MEMORANDUM

Date : June 30, 2009

Subject : **Response to Comments of the NRC Report on ATSDR Water Modeling Study.**

Figure 1. Location of the Tarawa Terrace Elementary School

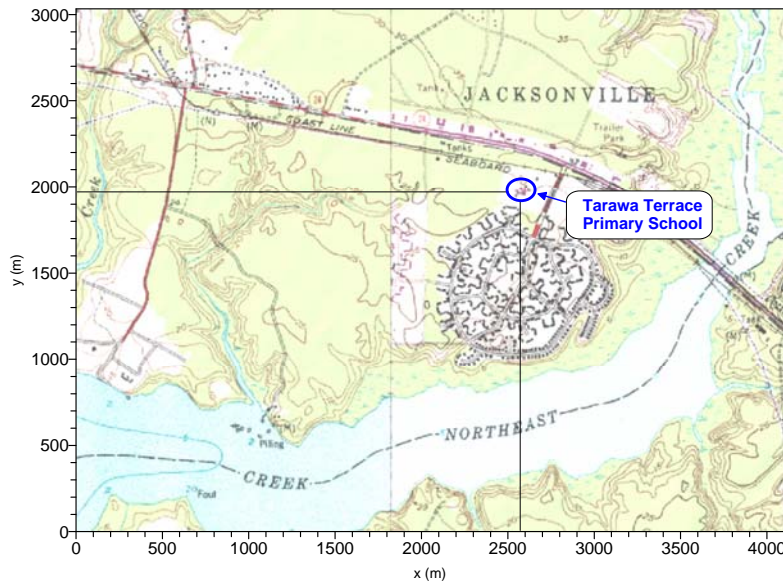
- 11. Comment on p. 49 bullet seven:** *The TechFlowMP model predicted very high vapor concentrations. For example, TechFlowMP predicted that the PCE vapor concentration in the top 10 ft of soil beneath the Tarawa Terrace elementary school should be 1,418 µg/L. Studies of PCE vapor concentrations in buildings that house or are near a dry-cleaning facility have reported measured concentrations around 55 µg/L.*

In order to analyze the concentration distribution around the school area as it is referred to in the aforementioned NRC report comment, the location of the school at Tarawa Terrace has to be identified, and it shown in Figure 1.
